NOVA-DETECTOR_PROTOTYPE
IPND PVC MODULES
16 CELL HORIZONTAL EXTRUSION

SCALE	DRAWING NUMBER	SHEET	REV
1:8	3929.000-MD-444812	1 OF 1	A

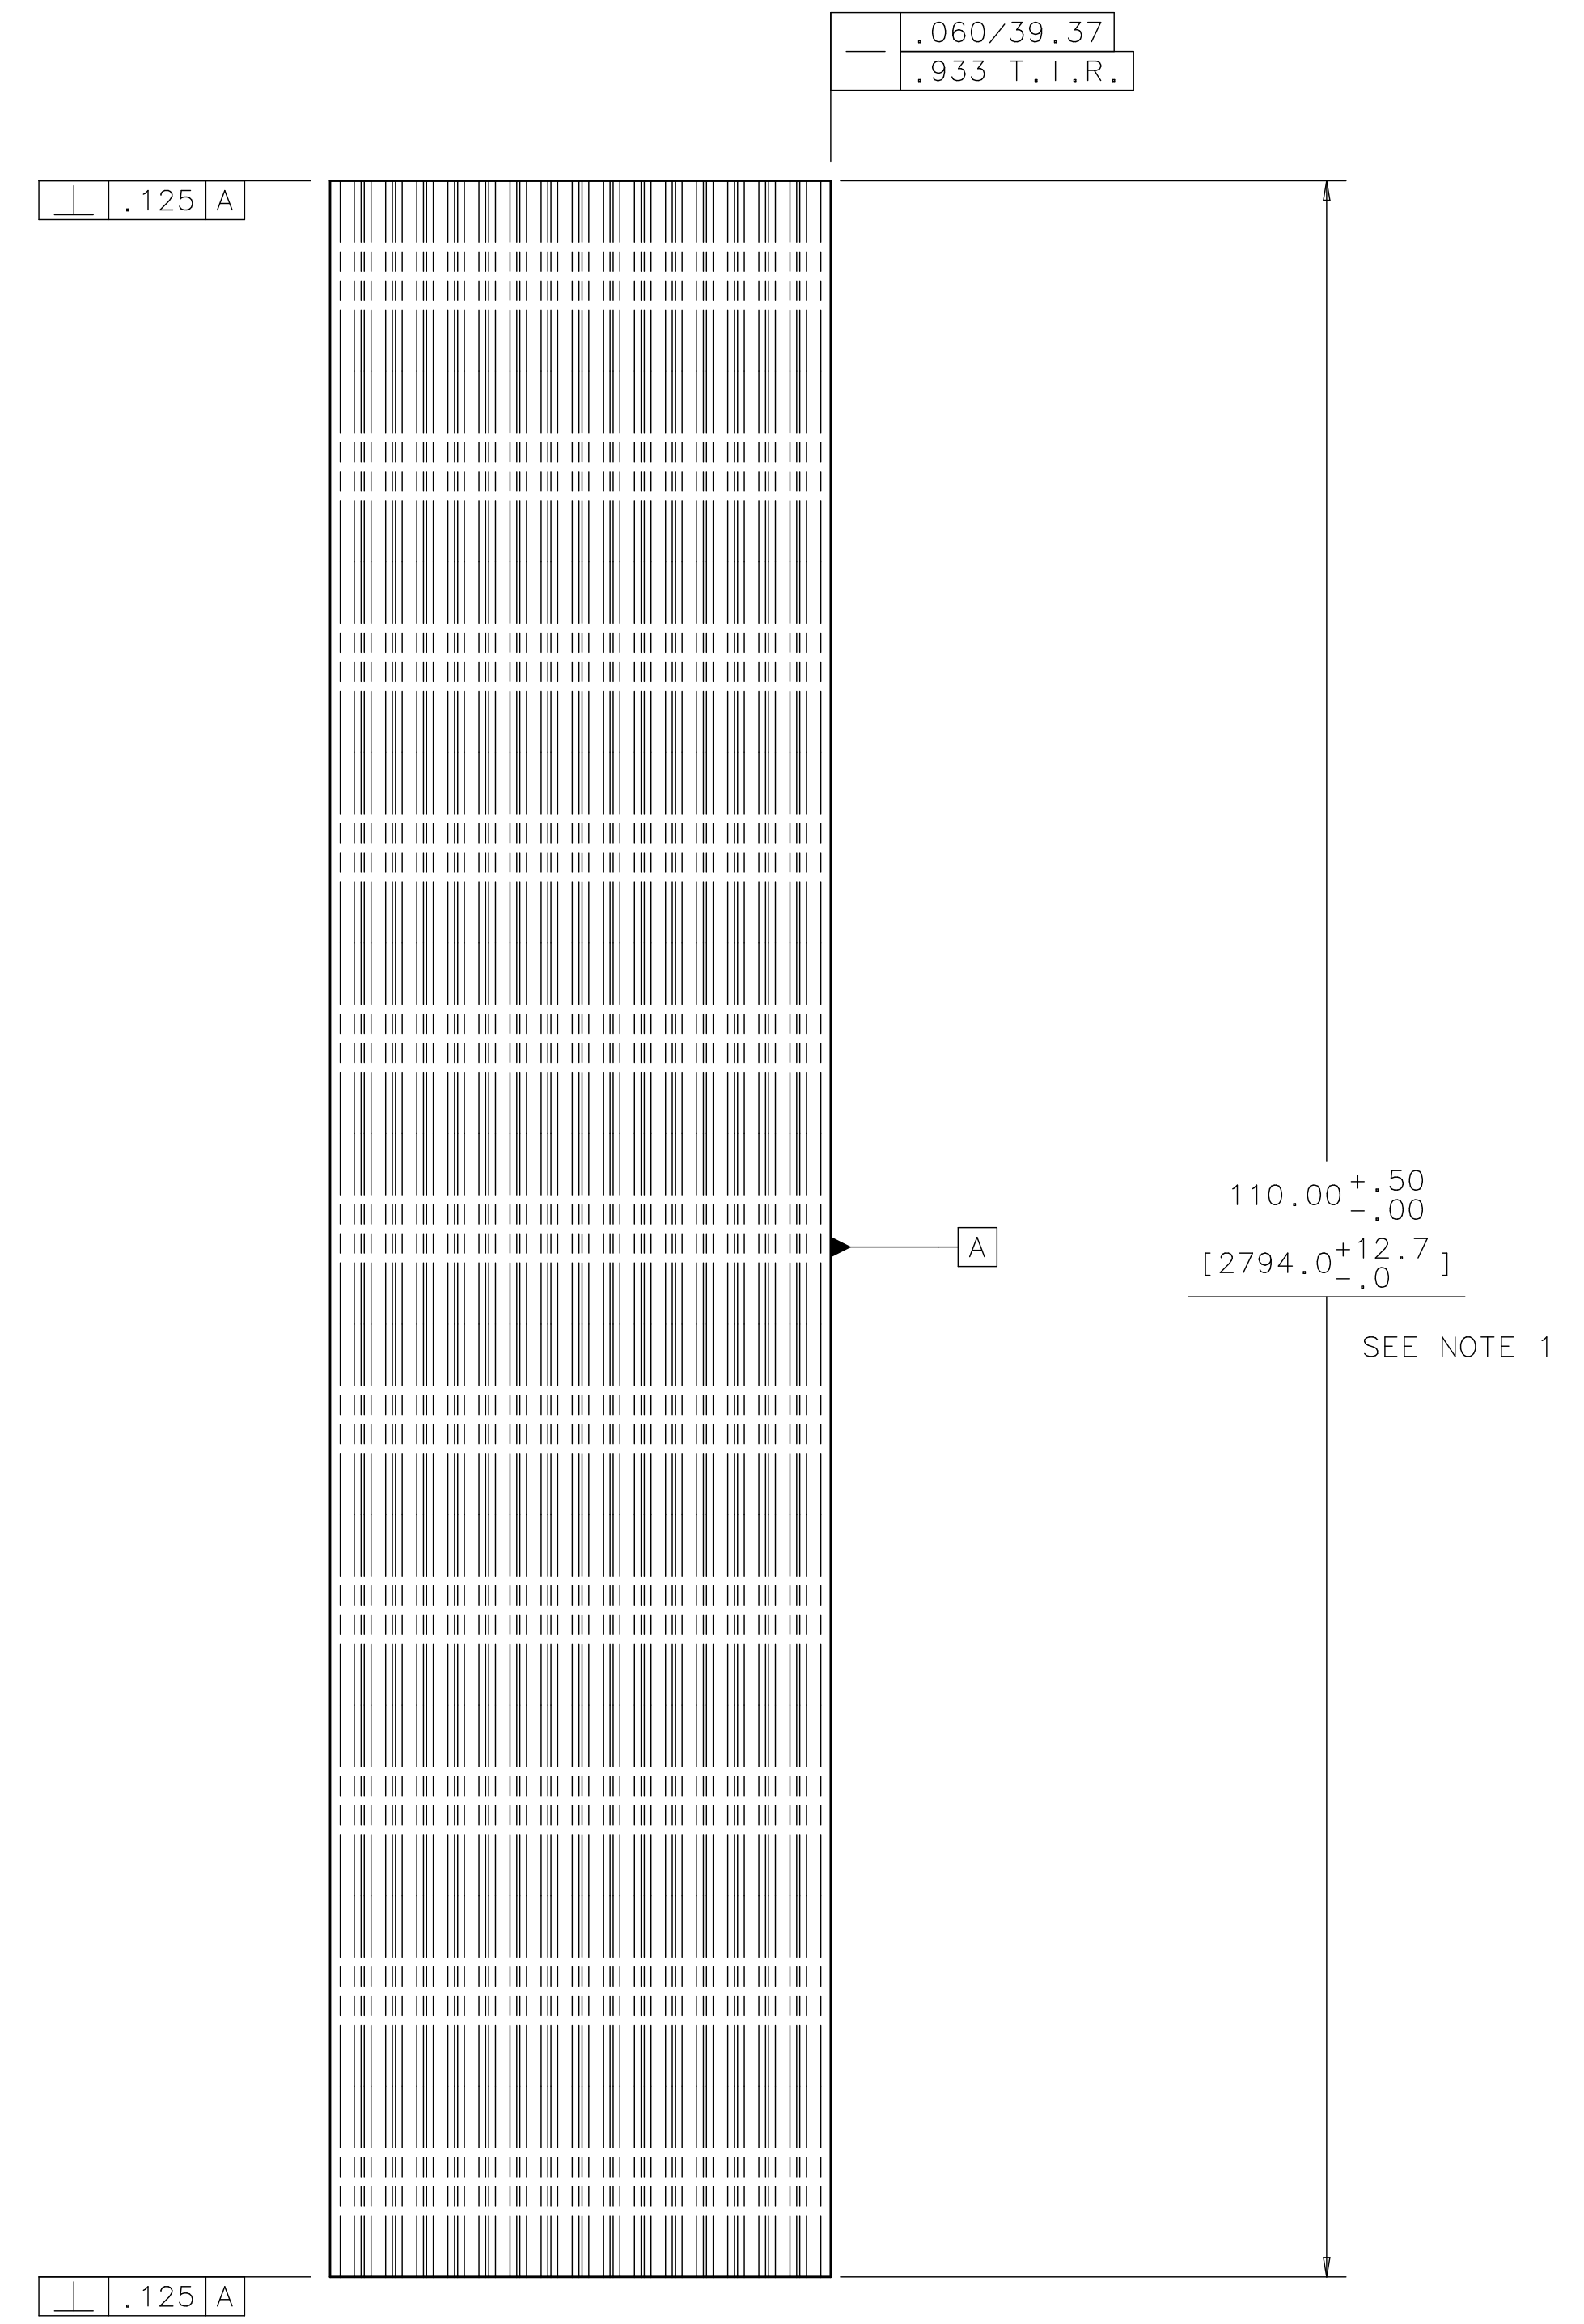
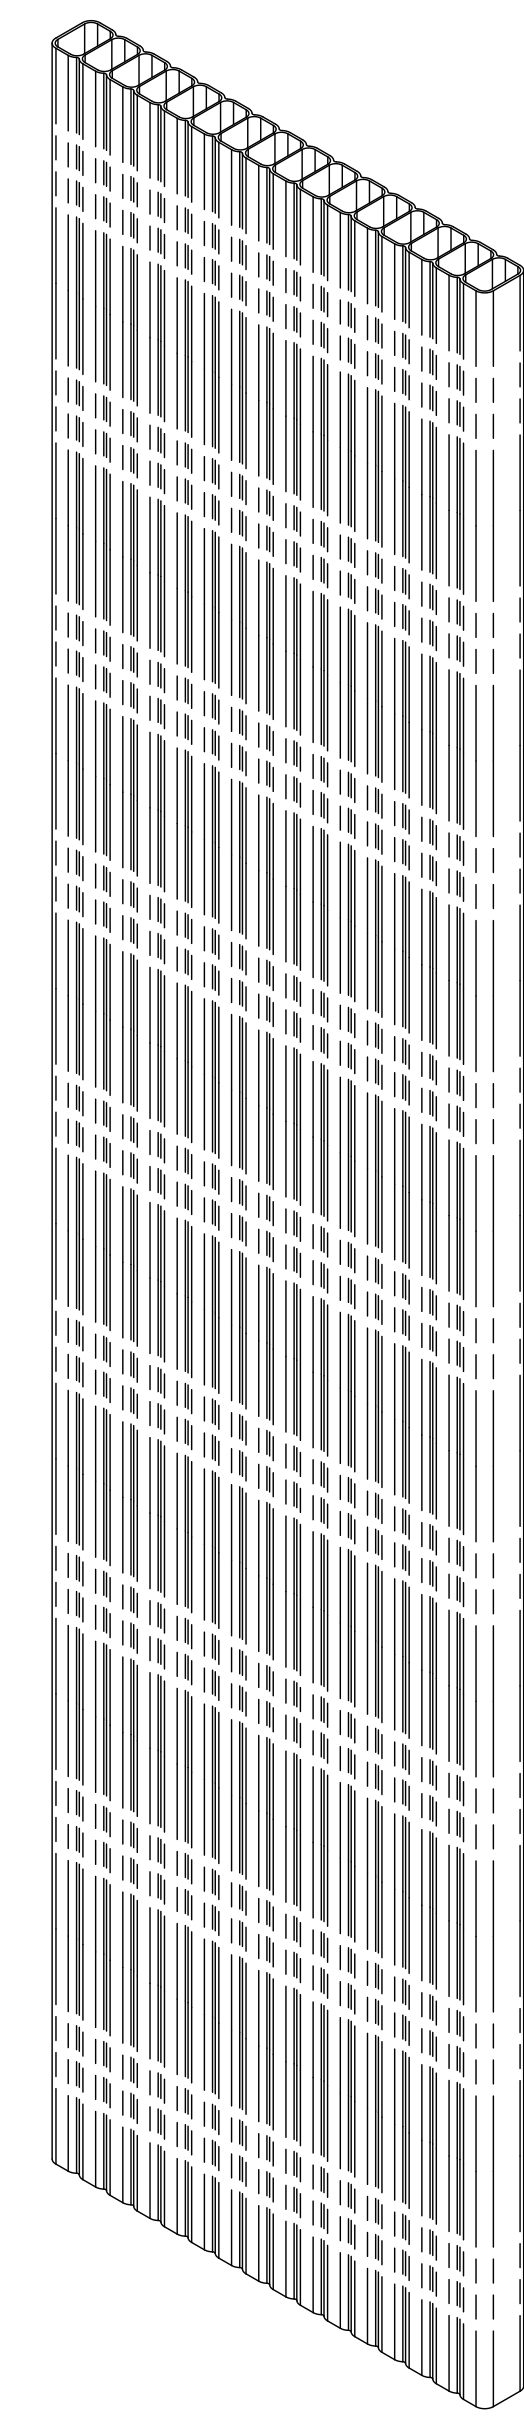
REV	DESCRIPTION	DRAWN	
		APPROVED	DATE
A	CHG'D NOTE 3 WEIGHT FROM 42 LBS TO 63 LBS.	D. FRIEND	02-SEP-2009
		GARY W. SMITH	08-OCT-2009

1. LENGTH AS DELIVERED FROM EXTRUDER MANUFACTURER.
2. ALL DIMENSIONS EXPRESSED IN INCHES WITH MILLIMETER BELOW
3. ESTIMATED WEIGHT IS 63 LBS.
